Access Compliance Report Public Rights-of-Way (Curb Ramps)

Intersection ID: 10027202 Main Street: GENTRY PL Cross Street: N/A Location: **Overall Compliance: No** ADA ID: D0304230AA7D Ramp Type: Perp Initial Pass/Fail: Fail **Severity Score:** 12.5

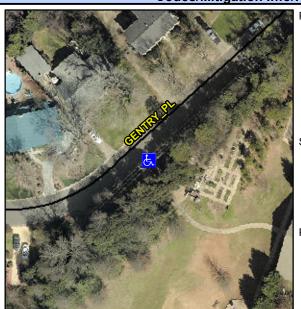
Possible Solutions:	
Remove & Replace Entire Ramp.	ı
	`
Surveyor Notes:	I
N/A	ı
	ı
	ı
PROW/ADA:	
Not Found, R304.2.2	i
140t i Guila, 14004.2.2	Ī
	ı

Field Measurements/Component Compliance							
Comp	liance Description	Data	Comp	liance Description	Data		
N/A	Ramp Length (in)	23.0	No	Ramp Slope (%)	10.5		
Yes	Ramp Width (in)	48.0	Yes	Ramp XSlope (%)	0.1		
N/A	Flare Type LT	N/A	N/A	Flare Type RT	N/A		
N/A	Flare Slope LT (%)	N/A	N/A	Flare Slope RT (%)	N/A		
N/A	Flare Traversable LT?	N/A	N/A	Flare Traversable RT?	N/A		
N/A	Landing Length (in)	N/A	N/A	DWS Provided?	N/A		
N/A	Landing Width (in)	N/A	N/A	DWS Contrast?	N/A		
N/A	Landing Slope (%)	N/A	N/A	DWS Length (in)	N/A		
N/A	Landing X Slope (%)	N/A	N/A	DWS Full Width?	N/A		
N/A	Landing Curb? (Y/N)	N/A	N/A	DWS Offset (in)	N/A		
N/A	Shared Landing?	N/A					
N/A	Gutter Ponding?	N/A	N/A	Gutter Slope (%)	N/A		
N/A	Gutter Lip Ht (in)	N/A	N/A	Gutter X Slope (%)	N/A		
N/A	Painted X Walk1?	No	N/A	Painted X Walk2?	N/A		
	X Walk 1 Direction	To N		X Walk 2 Direction	N/A		
N/A	X Walk 1 Width (in)	N/A	N/A	X Walk 2 Width (in)	N/A
